REPORT TO APPLICATION DETERMINATION PANEL

107 Headland Road North Curl curl - Alterations and additions to a dwelling house

DEVELOPMENT APPLICATION ASSESSMENT REPORT

Application Number:	DA2015/0427
Responsible Officer:	Alex Keller
Land to be developed (Address):	Lot 11 DP 10571 , 107 Headland Road NORTH CURL CURL NSW 2099
Proposed Development:	Alterations and additions to a dwelling house
Zoning:	LEP - Land zoned R2 Low Density Residential
Development Permissible:	Yes
Existing Use Rights:	No
Consent Authority:	Warrarah Council Application Determination Panel
Land and Environment Court Action:	No
Owner:	Aaron Mark Greaves Heather Lo Rae Greaves
Applicant:	Boston Blyth Fleming Pty Ltd
Application lodged:	20/05/2015
Application Type:	Local
State Reporting Category:	Residential - Alterations and additions
Notified:	22/05/2015 to 06/06/2015
Advertised:	Not Advertised in accordance with A.7 of WDCP
Submissions:	6
Recommendation:	Approval
Estimated Cost of Works:	\$ 938,348

SOUTHERN ELEVATION

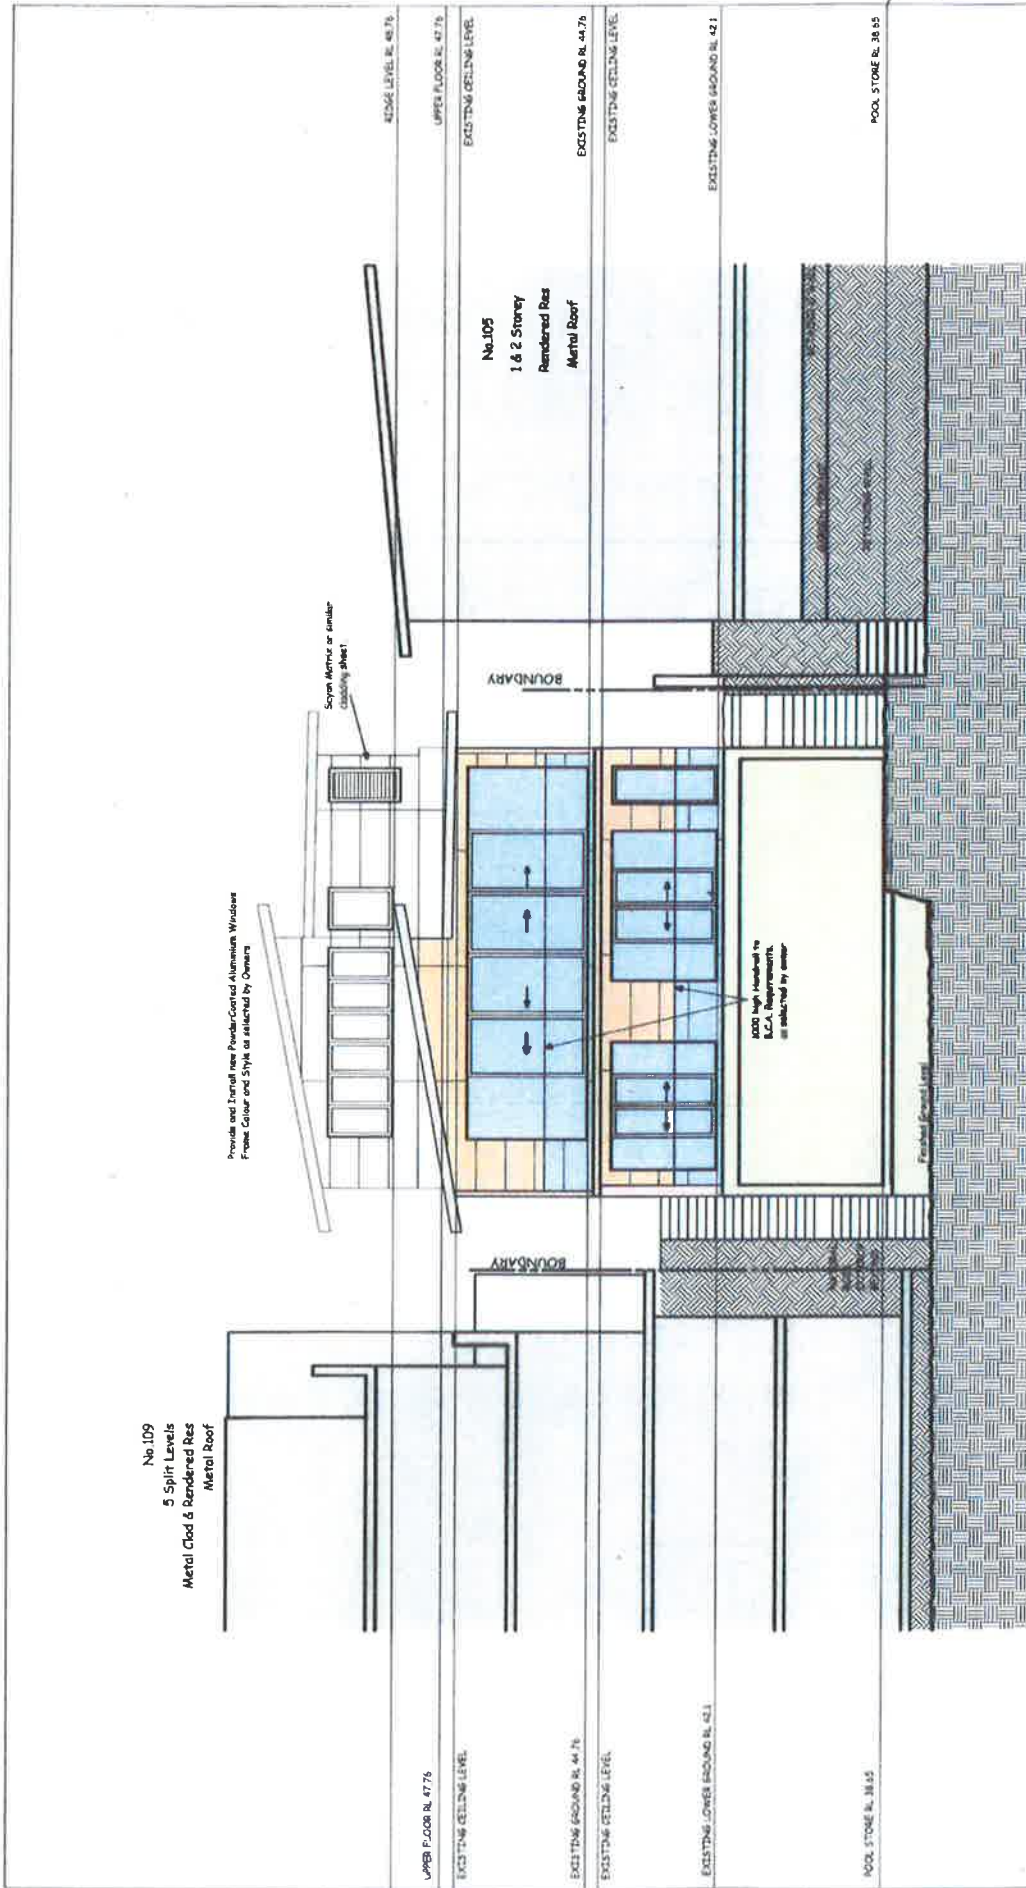
- The south-western corner and southern eave-line of the roof element at RL47.66 to RL48.76 above the ground floor tiled deck (RL44.66) is to be setback an additional 1.0 metre from the southern boundary, and transitioned (angled) toward the existing setback for the south-eastern corner of the same roofline; and
- The "1.0m high wall" balustrade shown on the plans for the rear deck, at RL44.76, is to be transparent glass.

EASTERN ELEVATION

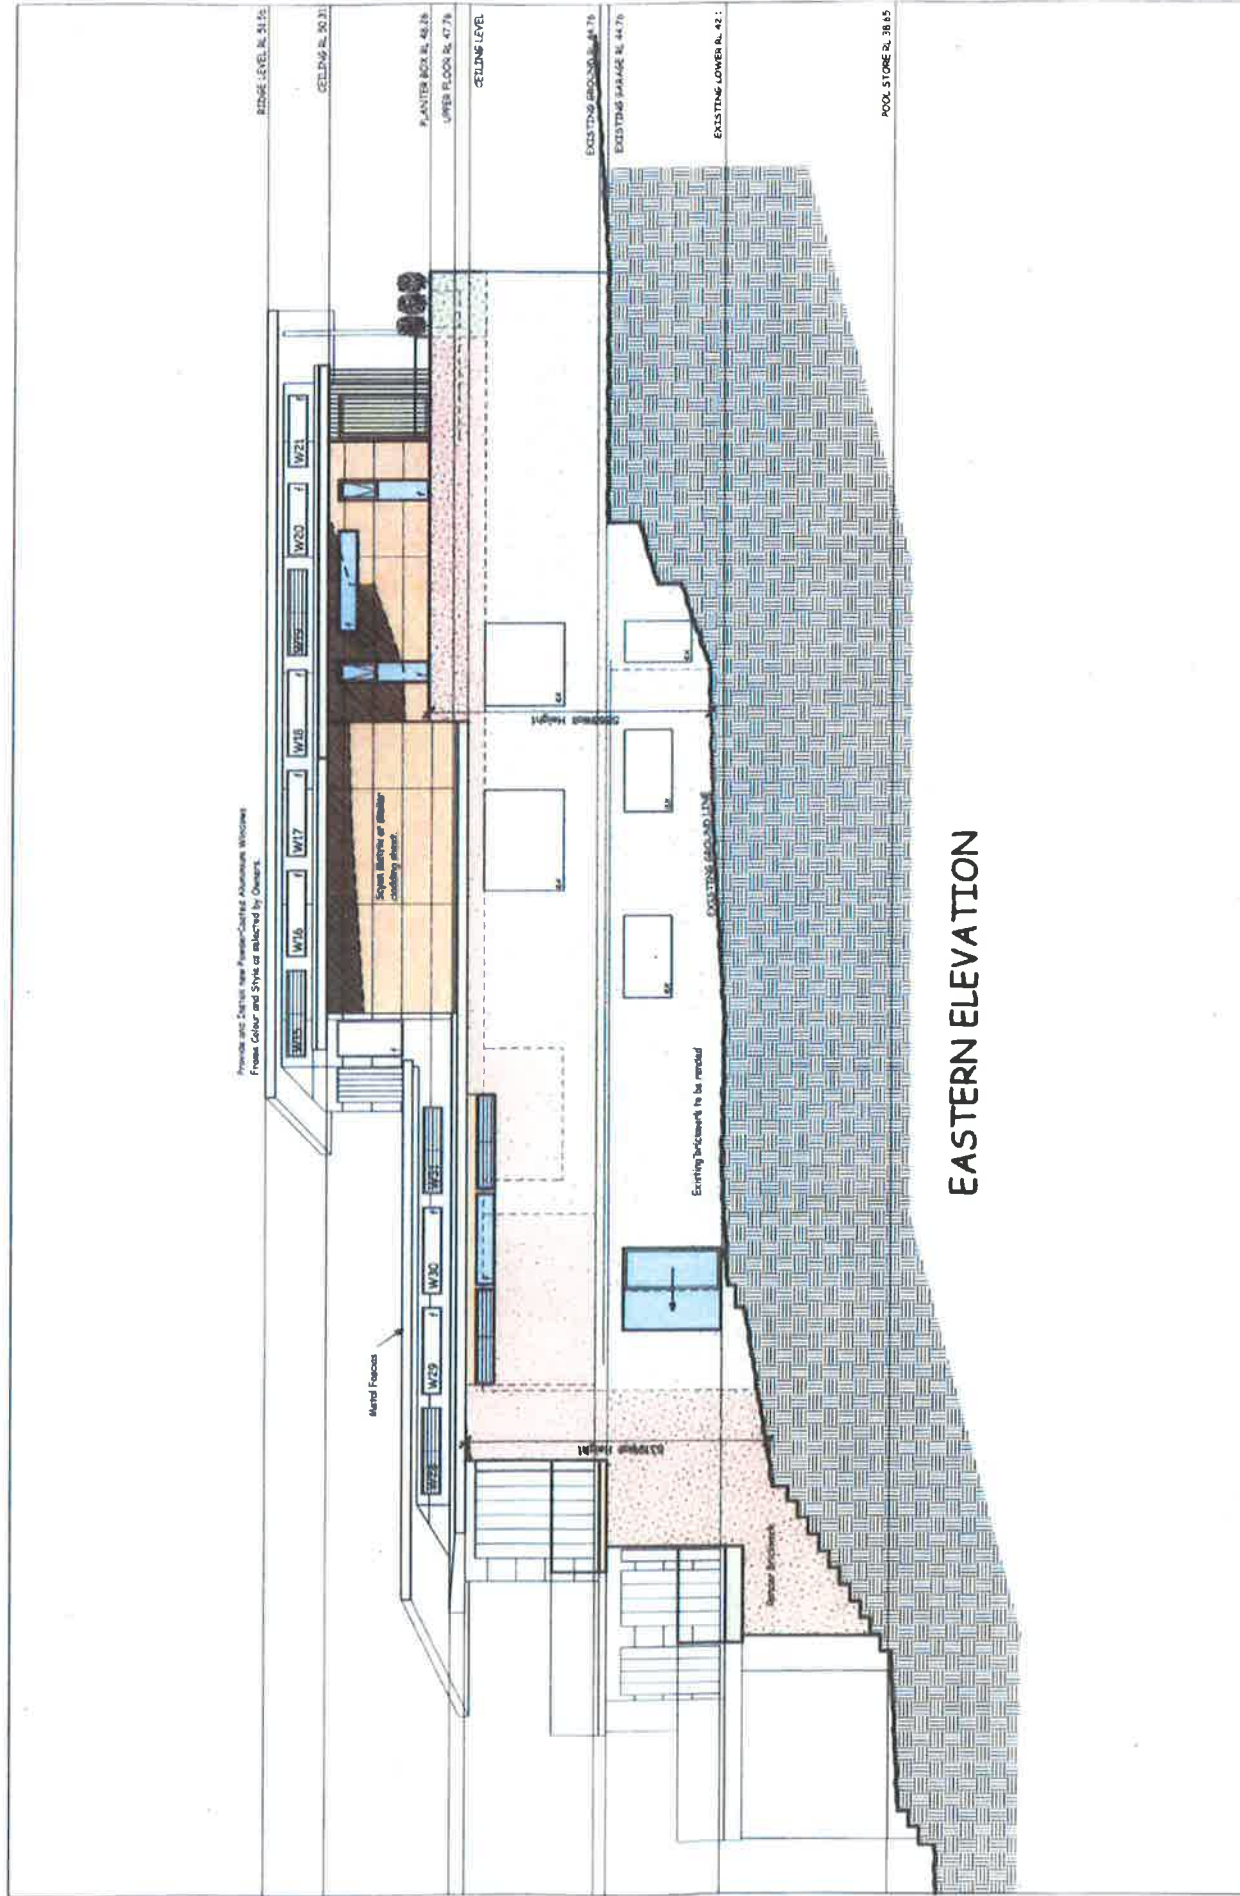
A maximum 300mm section of the along upper corner of the eastern elevation (kitchen / dining room wall) breaches the building envelope, as well as as up to 1.5m along the upper section of the western elevation (master bedroom wall) for the upper floor level.

WESTERN ELEVATION

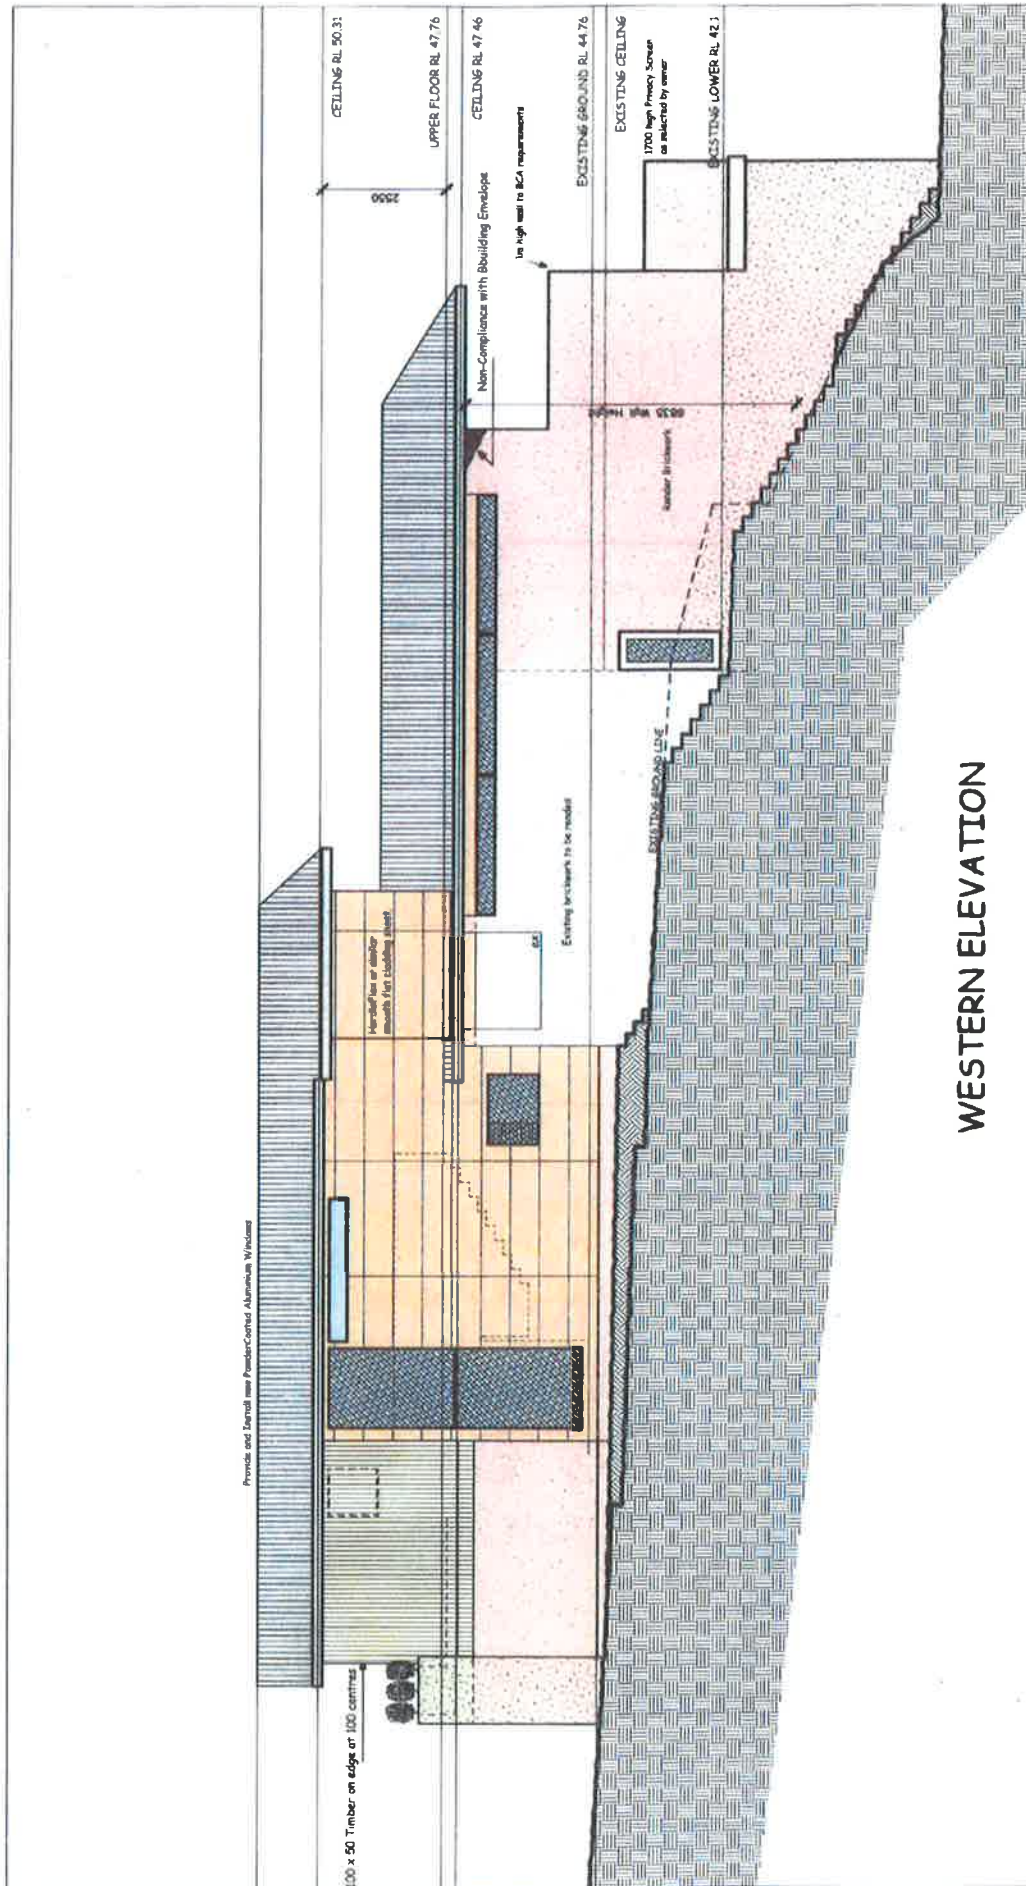
The maximum wall height is 7.5m, and the proposal has a non-compliance for the side wall for part of the eastern and western elevation of the building.
